# Groundwater Transfer Review Summary Form

Transfer/PA # T- 14477

Application: T-14477

Applicant Name: William and Kathleen Mitchell

**Cross section of selected wells near the proposed APOA suggests the possibility of encountering bedrock at the proposed drilling location and depth, as nearby wells of similar depth have.**

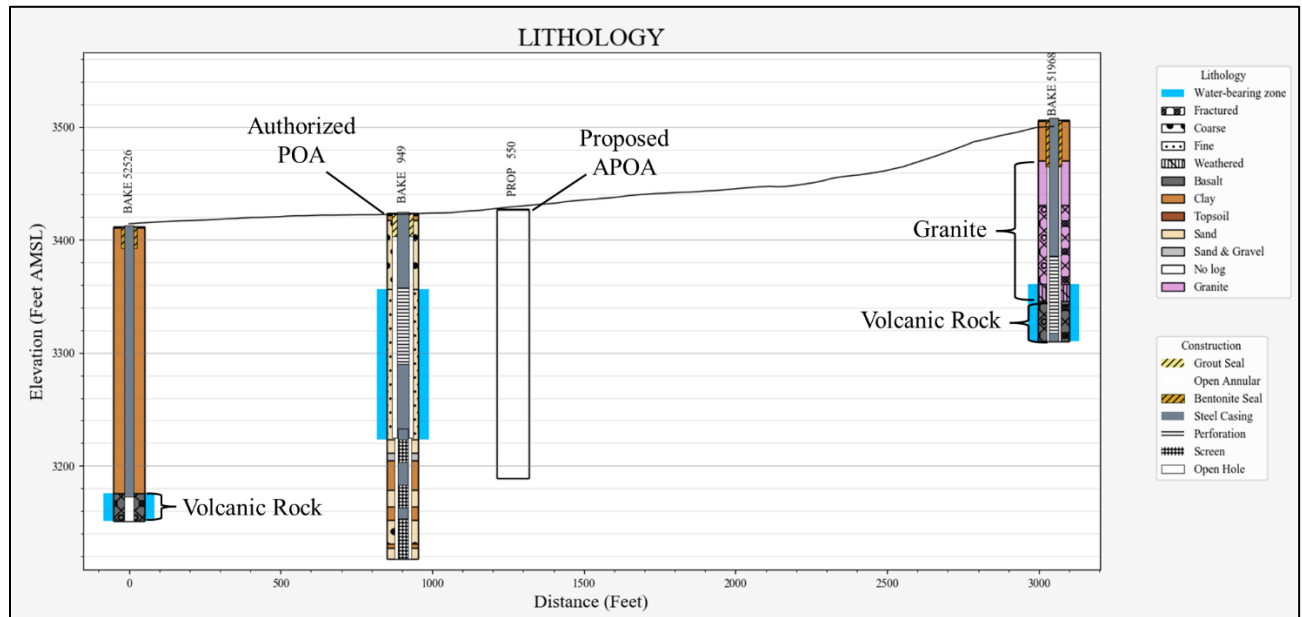
7. What conditions or other changes in the application are necessary to address any potential issues identified above: The proposed well construction includes a total depth of 238' but does not specify details about casing and seal depth. In order to maintain production from the same source aquifer, the APOA well must be constructed to produce only from the alluvial aquifer. Nearby wells intersect basalt and granite at depth as displayed in the cross section diagram below.

APOA Construction Condition: If volcanic rock or granite is encountered during drilling, these lithologies must be sealed off from the borehole to limit groundwater production from the overlying sedimentary sequence.
